MEMORANDUM

SUBJECT: Project Plan Review No. 9-05005
Preliminary Plan Review No. 1-05089
The Galaxy

SUBJECT: Project Plan # 9-05005 and Preliminary Plan # 1-05089
The Galaxy RST Development
Silver Spring Central Business District

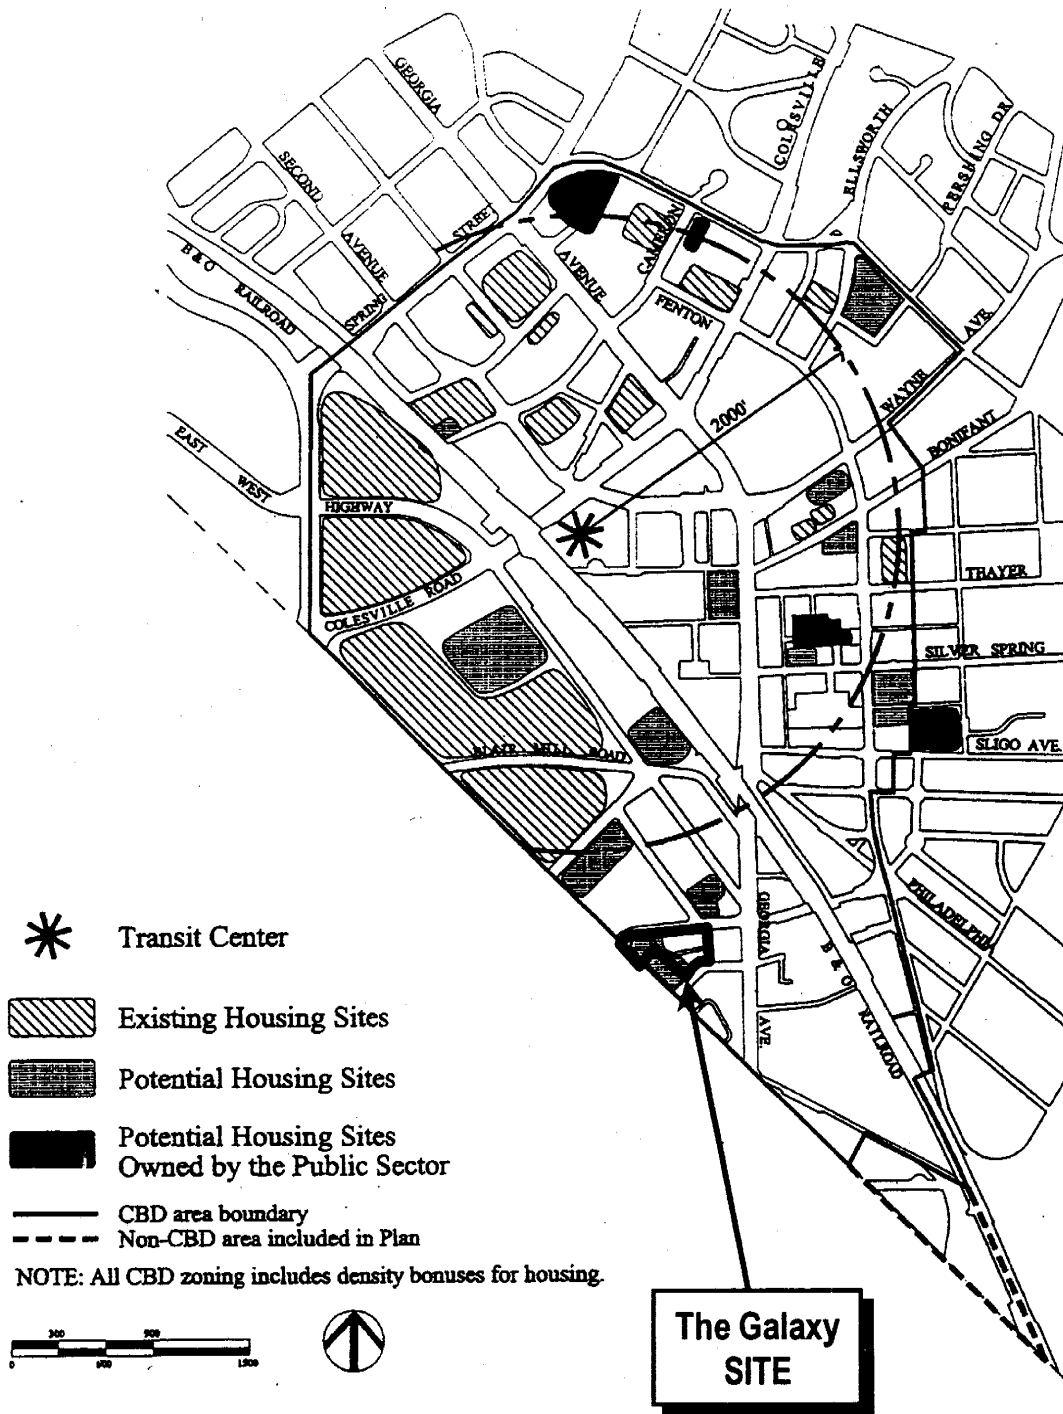
The Pathways identified as "Later Phases" are generally organized along existing public alleys. The development of the Aurora condominium project (i.e. the Williams and Wilste buildings) effectively dismissed one of the links (between the two buildings) to the existing alley located on the Galaxy property. The existing public alley is the subject of the proposed abandonment petition (AB 667). The applicant is proposing to implement one of the pathways (the Art Walk) as part of the public use space requirement. This linkage will connect 13th Street with King Street and is located between the subject property and the Ramada Inn and car wash properties. Staff encourages an open dialogue between the applicant, DHCA and other interested parties as the design of the proposed Art Walk continues to evolve.
